Peer Review of Balgal Beach Flood Study

Townsville City Council
A10416
005
00
26 April 2022

Title	Peer Review of Balgal Beach Flood Study
Project No	A10416
Deliverable No	005
Version No	00
Version Date	26 April 2022
Customer	Townsville City Council
Classification	BMT (OFFICIAL)
Author	Barry Rodgers
Reviewed By	Cathie Barton
Project Manager	Barry Rodgers

Figure 3.1 XP-RAFTS subareas with arrows showing cross over from Hencamp Creek to Rollingstone Creek

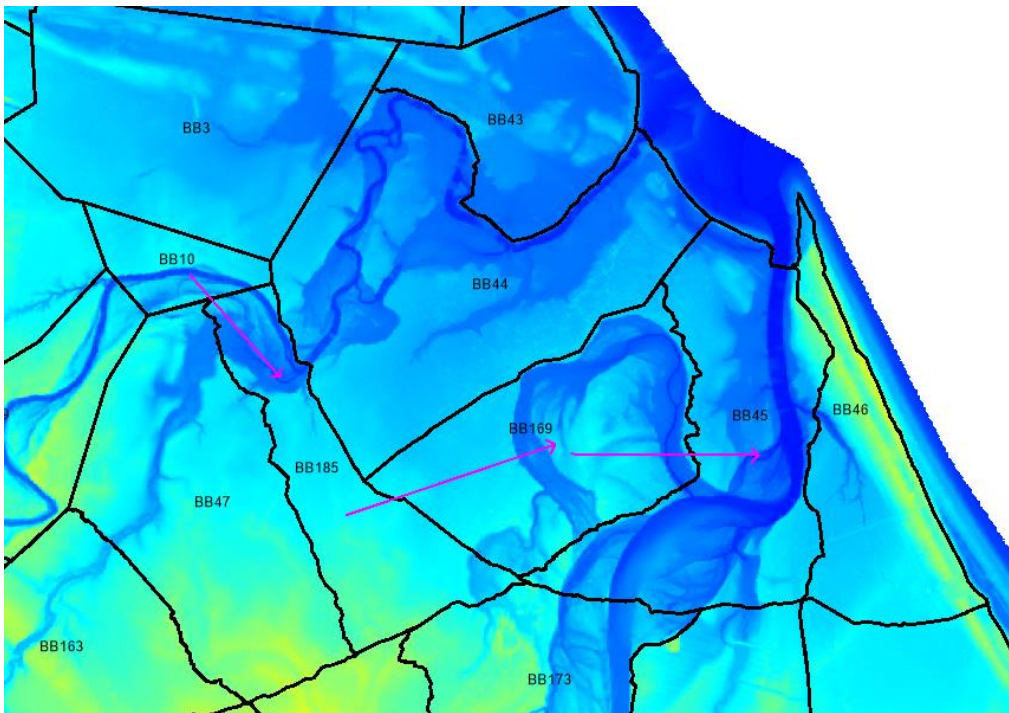
The XP-RAFTS subarea ordering has been reviewed against topography and was found to be generally satisfactory. An issue was noted in the lower reaches of the catchment where subarea BB185 (conveying the total running flow hydrograph in Hencamp Creek) links to subarea BB169 (Rollingstone Creek) (see Figure 3.1). As these subareas are all located within the area to which direct rainfall is applied in TUFLOW then this issue within the hydrologic routing will not affect the TUFLOW results. Care should be exercised if using the hydrologic model for extracting flows in the lower reaches without the accompanying use of the TUFLOW model.

3.3	Hencamp Creek appears to erroneously flow into Rollingstone Creek in the lower reaches of the catchment.	Will not change study outcomes as area is within hydraulically routed TUFLOW domain. Recommended that this is reviewed and fixed for completeness and future usability of the model.

Figure 4.1 Culvert Structures with Missing 2D Embankments near Hencamp Creek

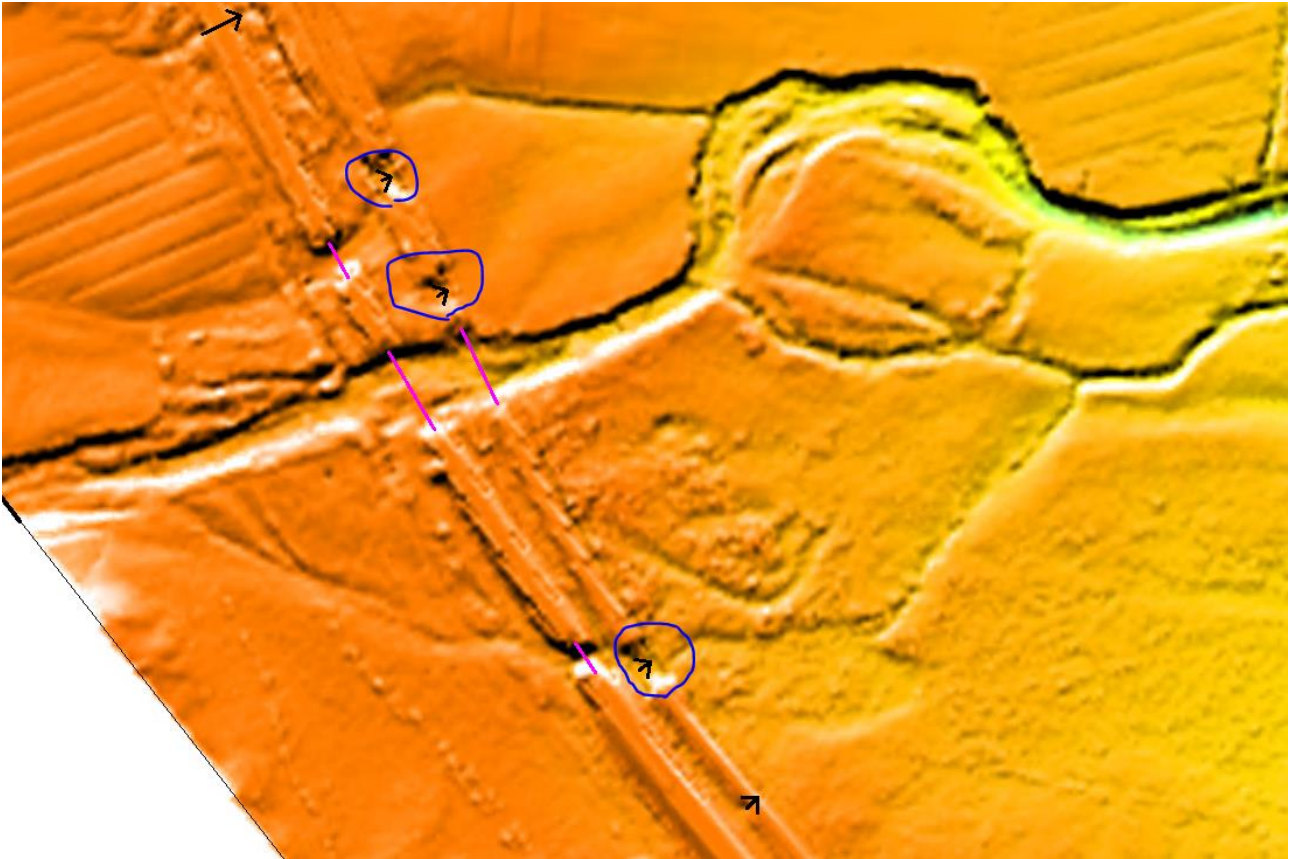
The model includes 103 culverts modelled as nested 1D elements. No issues were identified with the 1D elements but it was noted that a small number of culverts conveying drainage through the railway line were not obstructed in the 2D domain. This can lead to a double accounting of flow. An example of this near the Bruce Highway crossing of Hencamp Creek is shown in Figure 4.1 below. The magenta lines show bridge structures appropriately modelled in 2D as layered flow constrictions. Breaks in the highway/railway allow flow to pass through the flow constriction. Culverts modelled in 1D are shown as black arrows. Where culverts are modelled, the embankment through which they pass should be represented in the 2D component of the model. In this way, flow can then only pass through the 1D culvert or over the top of the embankment within the 2D domain. Figure 4.1 highlights three locations (blue circles) where the embankment has been removed through the LiDAR filtering process but where there is a modelled culvert present.

The double accounting of flow can lead to an understatement of upstream flood levels. This would be most pronounced for smaller to moderate events when the railway is not overtopped. It is recommended that road embankments are included in the 2D domain at all locations where there is a culvert modelled in 1D.

4.7	A double accounting of flow occurs at a number of the cross drainage railway crossings with flow passing through the 1D modelled culverts and through the 2D domain.	Affected locations should have embankments enforced in the 2D domain.
